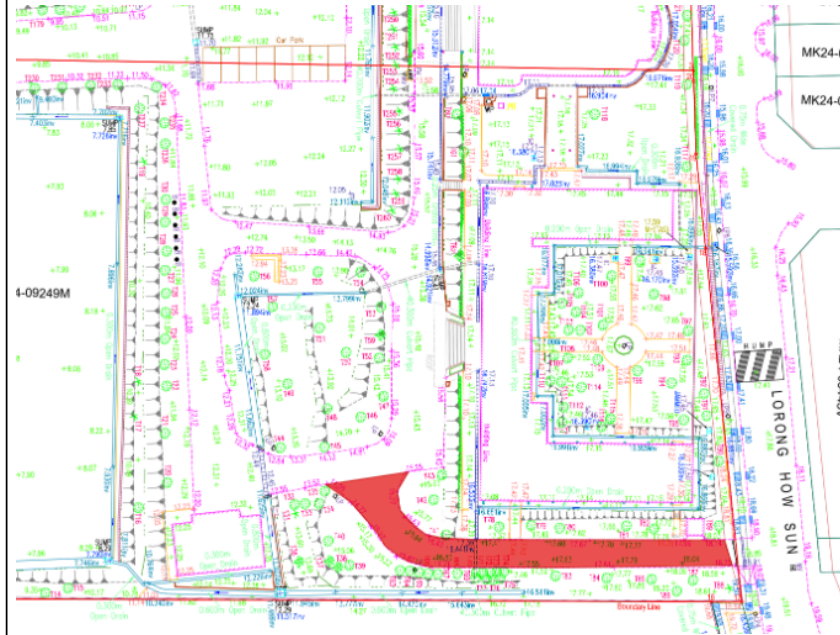
28	<p><b>Query: Building height</b></p> <p>Regarding the statement “<b>The proposed new cultural centre should not be higher than the driveway serving the conserved buildings (SHD 115.48m)</b>”, we would like to seek clarification on the following points:</p> <p><b>a. Definition of Height for the Proposed New Cultural Centre</b>          Could you specify what is meant by the “height” of the cultural centre in this context?          - Does it refer to the absolute highest point of the building (e.g., top of roof, parapet, dome, lantern, or any rooftop structures)?          - The top of the highest occupied storey?          - Or the finished floor level (FFL) of a particular storey?</p> <p><b>b. Reference Level of the Driveway (SHD 115.48m)</b>          In the phrase “...the driveway serving the conserved buildings (SHD 115.48m)”, does this mean:          - The new development must not exceed the physical height of the driveway itself?          - Or that the building height must not exceed the stated Survey Height Datum (SHD) of 115.48m, regardless of the driveway’s physical profile?</p> <p><b>c. Roof Forms Exceeding the Stated Height</b>          - If the cultural centre includes a dome, pitched roof, or other sloping/curved roof forms, are these architectural features allowed to exceed the stated driveway height (SHD 115.48m)? Or must all elements of the building—including roof peaks and domes—remain below the specified height limit?</p> <p><b>Query: Centenary Gate</b></p> <p><b>d. Purpose of the Centenary Gate</b>          Could you clarify whether the “Centenary Gate” referenced in the brief is intended specifically as an entrance feature for the proposed new Vivekananda Cultural Centre, or whether it is meant to serve as a gateway for the entire Ramakrishna Mission compound?</p> <p><b>e. Intended Users of the Gate</b>          Is the Centenary Gate designed to accommodate vehicular access (cars and service vehicles), pedestrian access only, or both?</p>	<p><u>Answers to item 28 a,b,c:</u></p> <p>The intent of the height guideline is to ensure that the new Cultural Centre maintains a respectful relationship with the conserved buildings behind it. The stated datums are therefore meant to serve as general reference points rather than strict height controls.</p> <p>Entrants are free to interpret “height” in a manner appropriate to their proposal, whether in terms of overall building massing, roofline, or key architectural elements. The SHD 115.48 m noted for the driveway is similarly intended as a contextual datum, not an absolute cap.</p> <p>Architectural features such as domes, pitched or sloping roofs may exceed these reference heights if well-justified and sensitively integrated, provided the overall composition remains compatible with the heritage setting. Designers are encouraged to exercise discretion and propose solutions that balance programme needs with thoughtful contextual response.</p> <p><u>Answer to item 28 d,e:</u></p> <p>The “Centenary Gate” is envisioned primarily as a commemorative threshold marking the Mission’s centenary and reinforcing the sense of arrival to the overall Ramakrishna Mission compound. Its exact relationship to the new Cultural Centre is intentionally left open for interpretation. Likewise, the mode of access is not predetermined — entrants may propose a gate designed for pedestrians, vehicles, or a combination of both, depending on how their overall site strategy best supports circulation, safety, symbolism, and the Mission’s long-term needs.</p>
